RE: **Lot 5 Block 7 Volcano Cliffs Unit 18 SAD 228
6516 Pato Rd. NW
Grading and Drainage Plan
Engineers Stamp Date 5/12/2020 (D10D003L5)**

Based upon the information provided in your submittal received 6/17/2020, this plan is approved for Grading Permit.

| SHEET TITLE: | | GRADING AND DRAINAGE PLAN | |

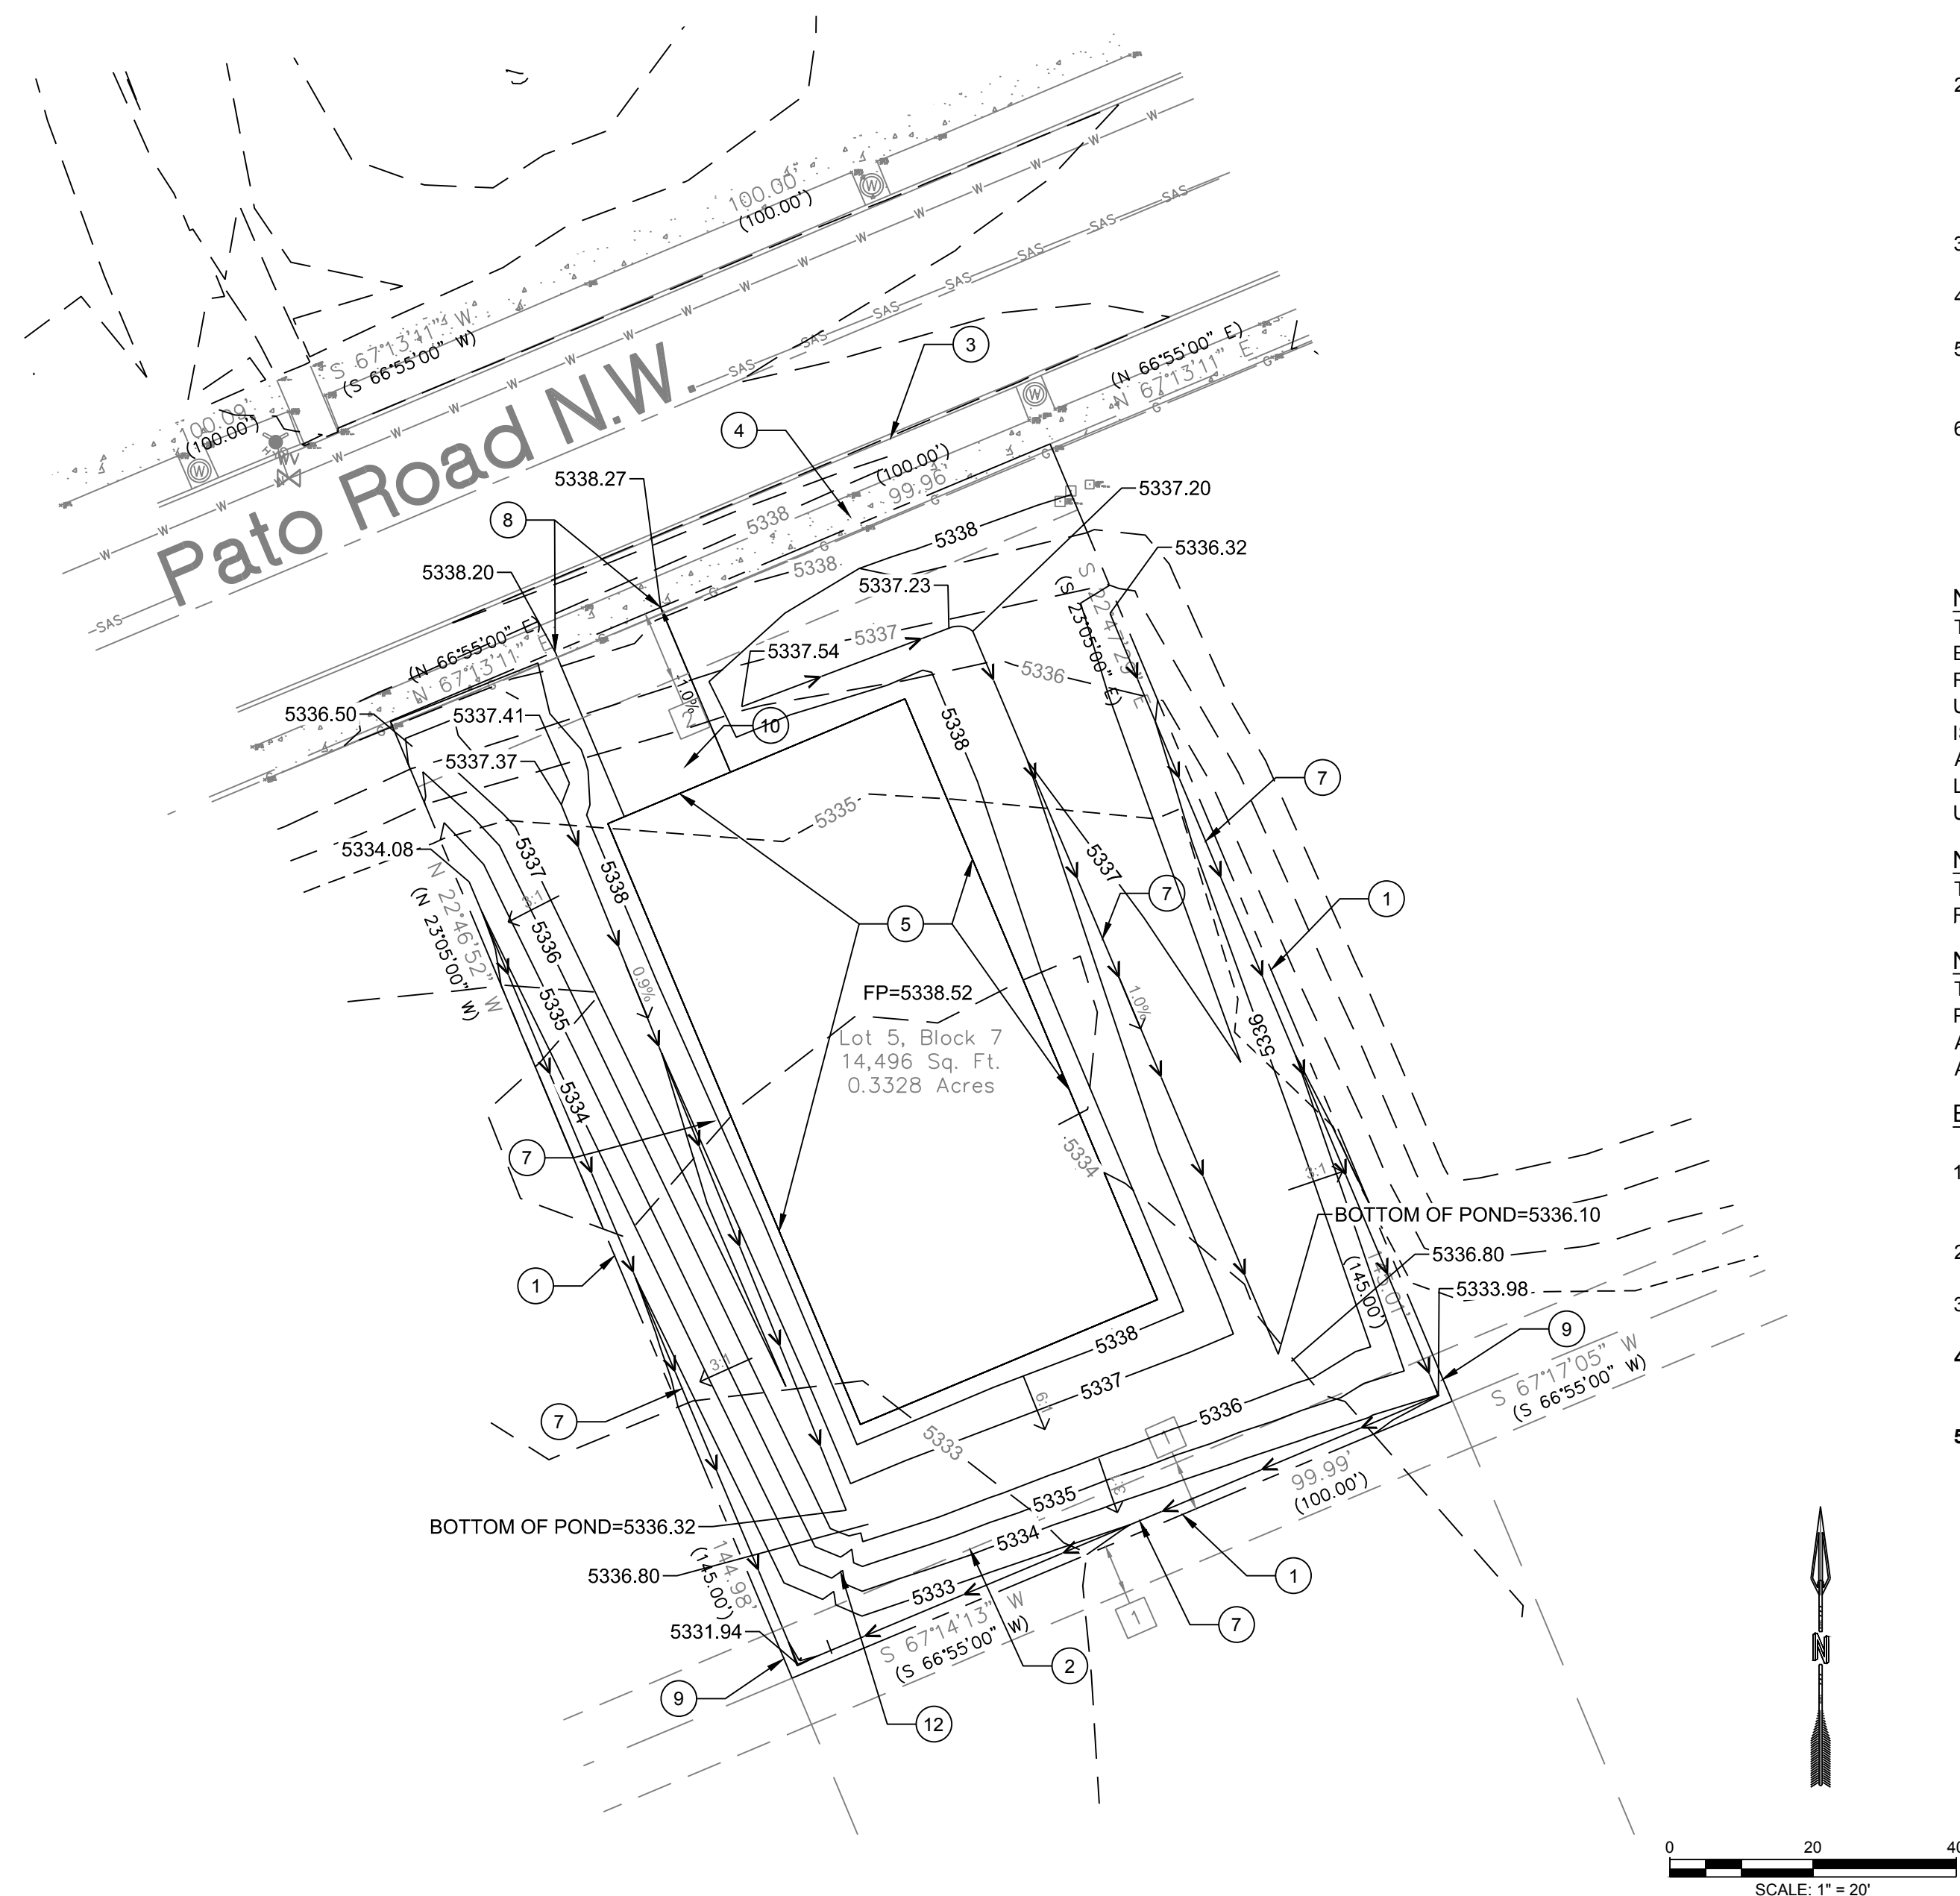
Prior to Building permit approval a Pad Certification will be required, provided by the Engineer or a registered Land Surveyor.

Reiterate to the Owner/Contractor that a separate permit for a garden/retaining wall must be obtained with the approved G&D plan and Pad Certification. **Also, if a swimming pool is to be placed the grading and drainage plan will change and will need to be resubmitted.**

Prior to Certificate of Occupancy release, Engineer Certification per the DPM checklist will be required.
